## Minutes of P1658 Standards Committee Meeting in Gaithersburg, Maryland USA – February 19, 2007

### Draft Standard for Terminology and Test Methods for Digital to Analog Converters

The block diagrams of Figure 13 are shown below:

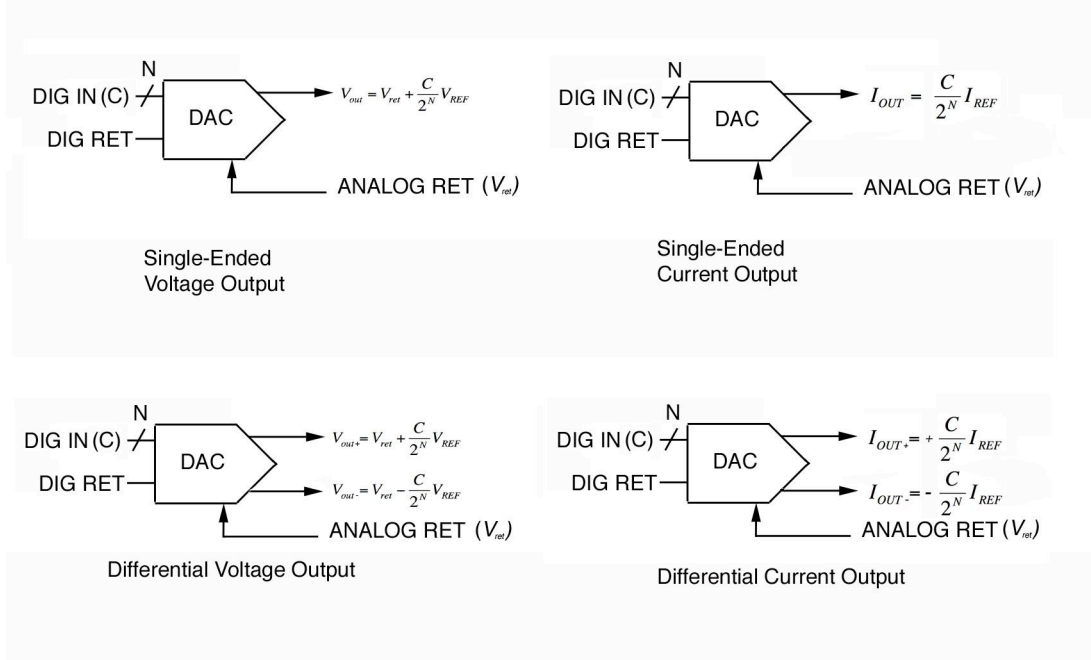
Pasquale agreed to modify them so that the term “Analog Ground Reference” will replace the term “Analog Return”.
